Moving Toward Resolution of TP3 Jitter Tolerance

Ali Ghiasi
Broadcom Corporation
aghiasi@Broadcom.com

IEEE Interim Meeting

XFP Transmitter Driving LRM Receiver

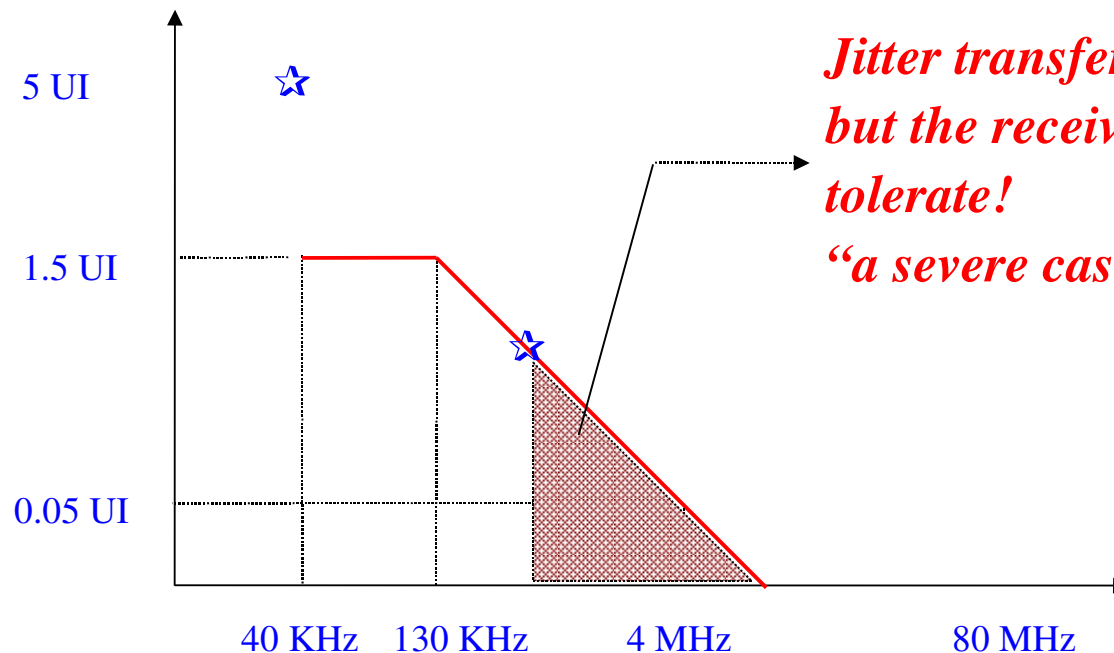
- **Current IEEE 802.3aq draft 2.2 only defines sinusoidal jitter tolerance at 40 KHz and 200 KHz when the transmitter PLL is 4 MHz.**
 - ⇒ For example in the frequency range of 200-400 KHz 1 UI to 0.5 UI SJ may be come through the CDR, which is more than enough to break any weak LRM receiver.

□ Assuming 4 MHz CDR BW in the XFP

⇒ Currently defined by IEEE shown as ☆

- Two options exist to resolve jitter tolerance test discrepancy and potential field problems
 - ⇒ Define transmit loop bandwidth of 200 KHz – Not practical
 - ⇒ Extend the current jitter tolerance from 200 KHz to 4 MHz with the following test frequencies:
 - 5 UI@40KHz, 0.5 UI@400KHz, 0.05 UI@4MHz, 0.05 UI 40 MHz.
 - Also add a note to Table 68-6 saying “above frequency point are provided as reference test point, LRM products must operate error free for all frequencies from 40KHz to 80 MHz when the tolerance points are connected by stright line.
